Product Change Notification

1. ECN #: 296251

- ASP-114463-01

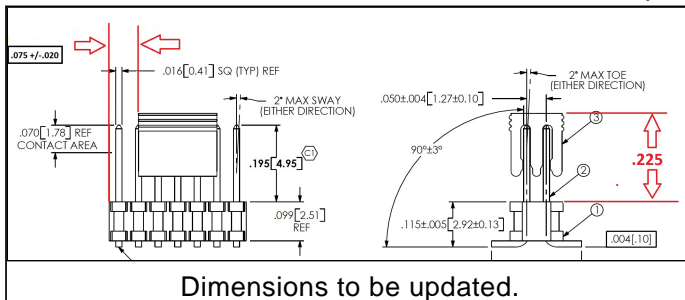
Print dimensional update of dimension .225 and .075 +/- .020 to control the pick and place pad height and location.

There is a concern that has been reported that the pick and place pad has not been properly assembled onto the product. The pad is not assembled flat on the product which affected the SMT machine pick up. In order to resolve this, dimensional control will be updated to control the pad height and location.

eQP #338886. Customer detected pad not assembled flat on the part which affected the SMT machine pick up.

- Form - Print has been updated with dimension .225 and .075 +/- .020 to control the pick and place pad height and location.
